AFFECTED MODELS: All 25"AND UPPER MODELS WITH 11AK19PRO CHASSIS .

REASONS OF CHANGE:

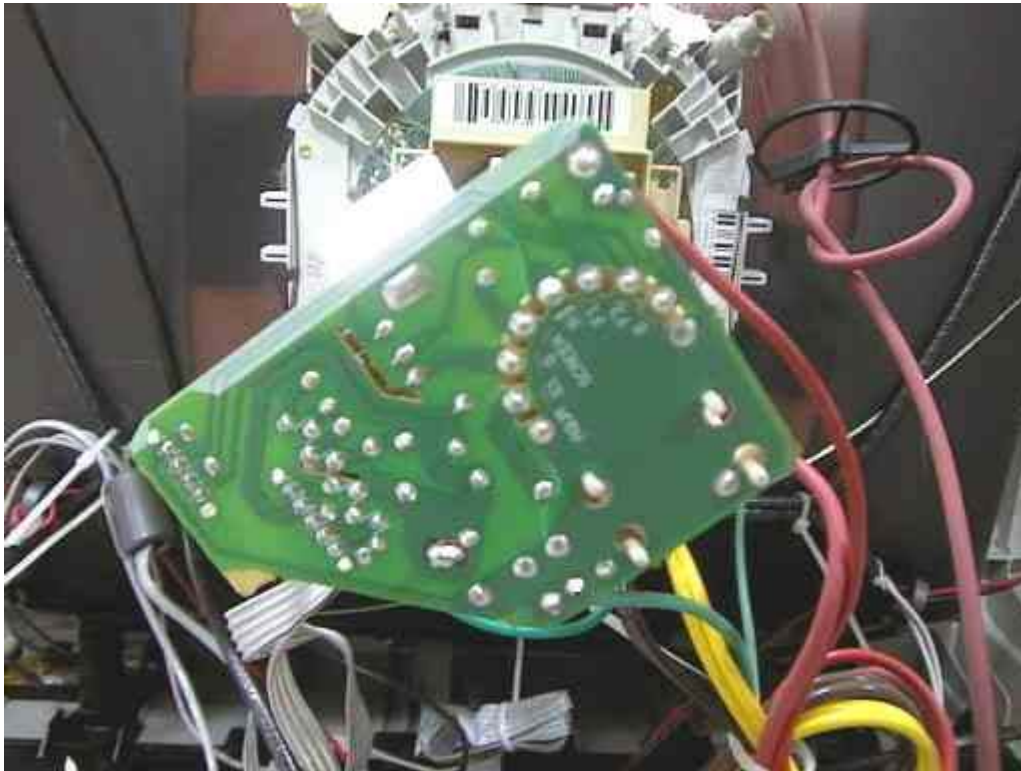
DEFECT OF THE RGB AMPLIFIER TDA 6108 ( IC 901 )  
TO CATCH A BETTER RELIABILITY ACCORDING SPARKS OF THE PICTURE TUBE THE CRT-BOARD  
WAS CHANGED . THIS NEW CRT BOARD AS ALSO AVAILABLE AS SPARE-PART .

**NOTE 1: WHEN THE NEW CRT-BOARD IS USED AS SPARE-PART , THE  
AVAILABLE CURRENT CONNECTOR CABLE BETWEEN CHASSIS AND CRT  
BOARD CAN BE USED .  
PAY ATTENTION FOR CONNECTING CABLE PL902 AND PL901 IN THE  
RIGHT POSITION ( SEE PHOTO )**

AQUA from CRT

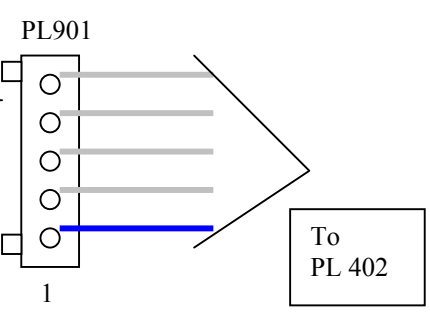
Green CABLE must be fix to SCREW of HOLDER of Deflection coil
